SUNDRY NOTICES AND REPORTS ON WELLS

P & A Procedure for Hallador Petroleum, LLP Horton #1A

Well: Horton #1A

CONDITIONS OF APPROVAL

HORTON #1A

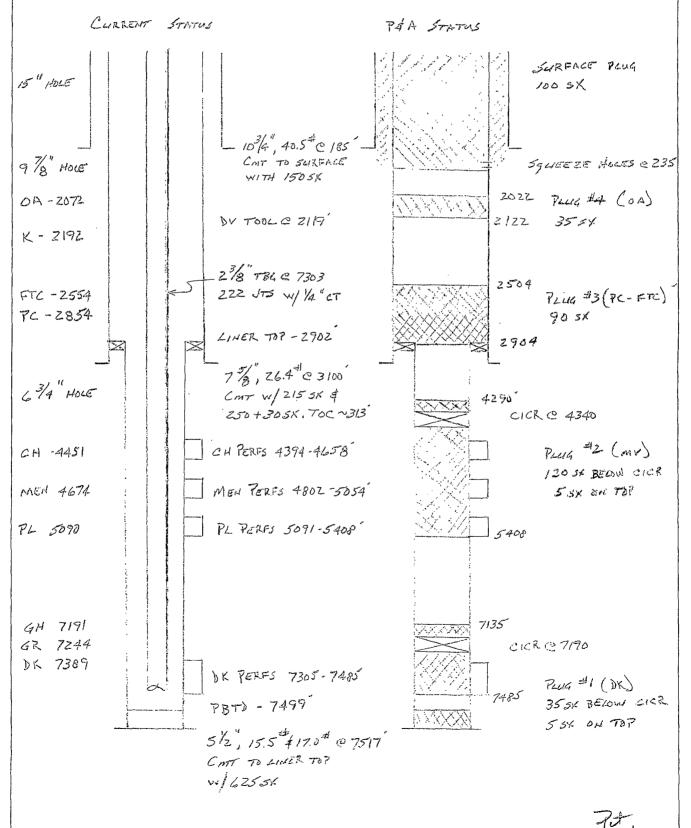
- 1. Plugging operations authorized are subject to the attached "General Requirements for Permanent Abandonment of Wells on Federal and Indian Leases."
- 2. Farmington Office is to be notified at least 24 hours before the plugging operations commence (505) 564-7750.
- 3. The following modifications to your plugging program are to be made:
 - a) Place an inside plug from (6524-6424) ft. to cover the Gallup top.
 - b) Place an inside plug from (5640-5540) ft. to cover the Mancos top.
 - c) Place an inside plug from (3595-3495) ft. to cover the Chacra top.
 - d) Bring the top of plug #3 to 2358 ft. to cover the Fruitland top. Adjust cement volume accordingly.

Note: H2S have been reported in this section; however, high concentrations of H2S (380ppm GSV) have been reported at the Case B #2 well located in the SW/SW of section 8,31N,11W. It is imperative that H2S monitoring and safety equipment be on location during the plugging operations at this wellsite.
